SUBDIVISION REVIEW SHEET

CASE NO: C8-07-0043.01

SUBDIVISION NAME: Avery Station Ranch Preliminary Plan

SUBJECT: Avery Station Subdivision Preliminary Plan – C8-07-0043.01

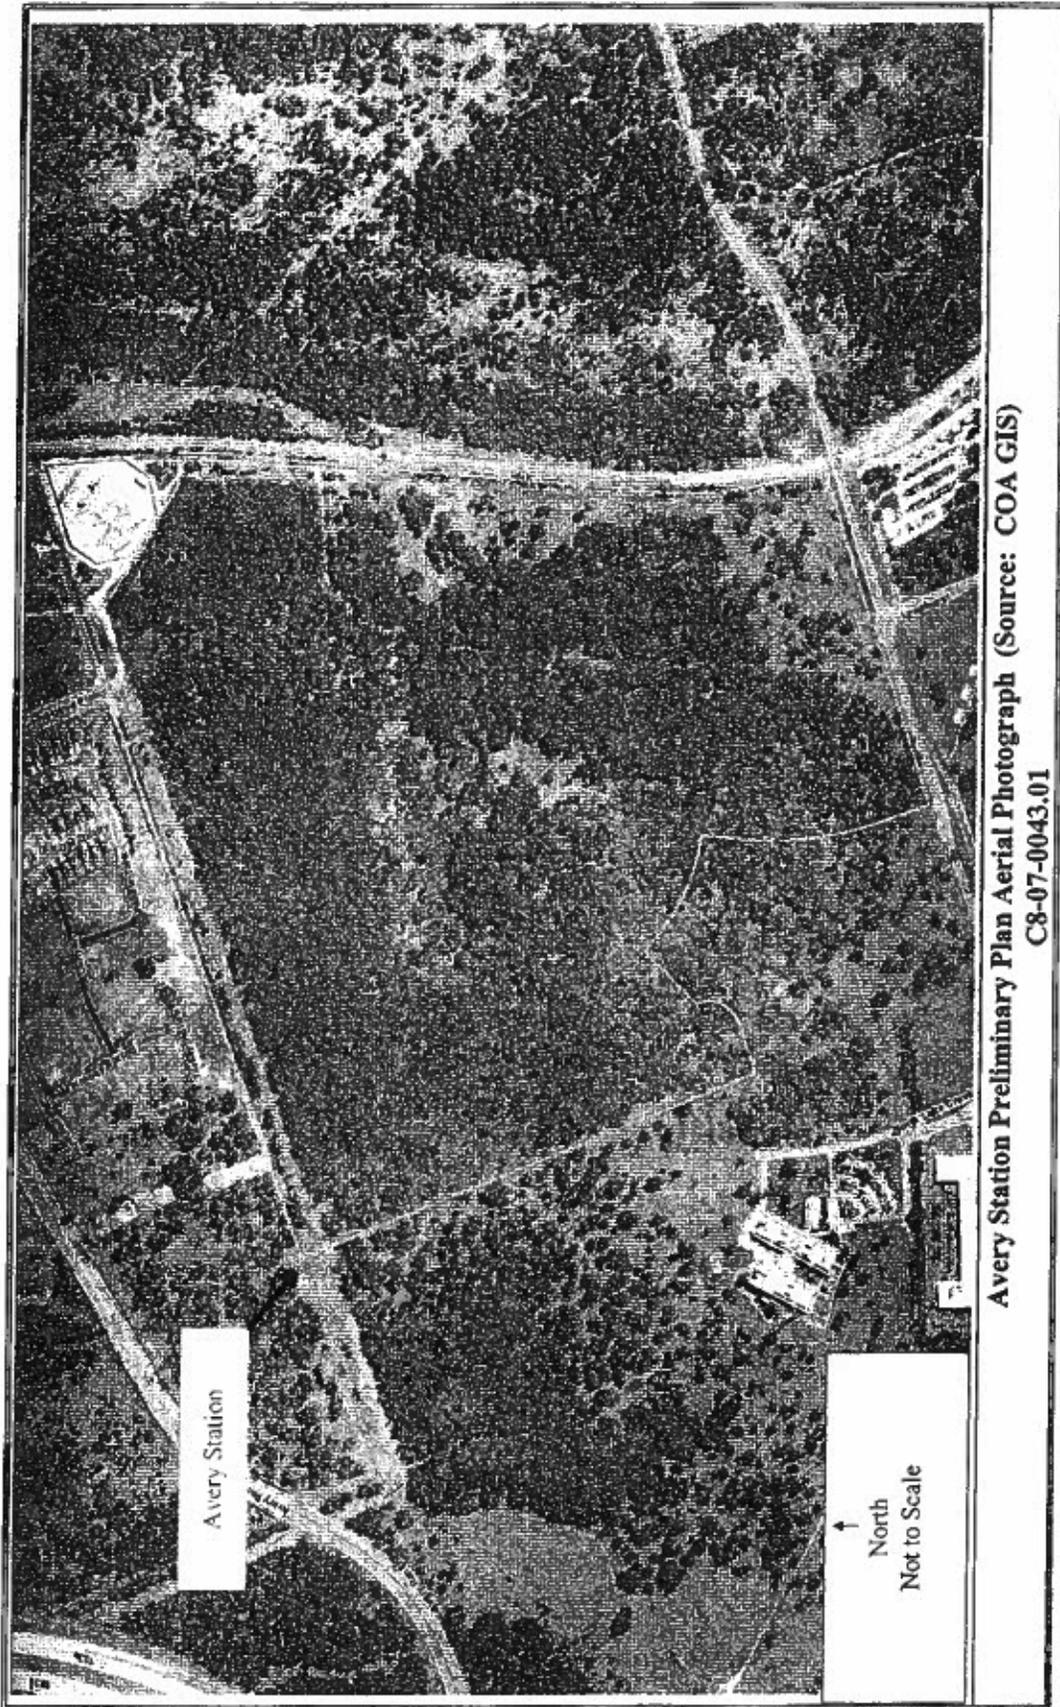
However, sediment will be contained on site and water quality will be preserved with the installation of silt fence, triangular filter dikes, inlet protection, and also by the construction sequence. Specifically, the applicant will rough cut the regional wet pond before initiating channel construction. Grading for both channels will then begin at the wet pond and proceed west. During rainfall events, sediment will be transported along the channels to collect in the wet pond and will be held on site. See the attached vicinity maps for the location of the proposed channels and wet pond, the location of South Brushy Creek, and the aerial view of the property.
